Service Manual

SUZUKI Automobile Genuine
AM/FM 6-Disc CD Changer Deck

Model PS-2533B-C,D
(Genuine No.39101-55GF1-000)

This additional service manual is designed to be used together with Original model.

(Reffer to page7 of original model's manual.)

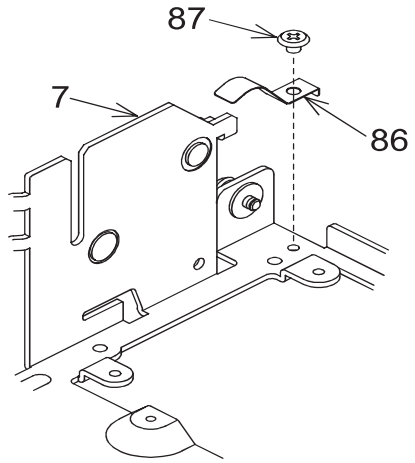
Original models also use below added parts.

NO.	PART NO.	DESCRIPTION	Q'TY
86	620-1604-20	DR-PLATE-SPRING	1
87	716-1850-01	SCREW(M2 x 2)	1
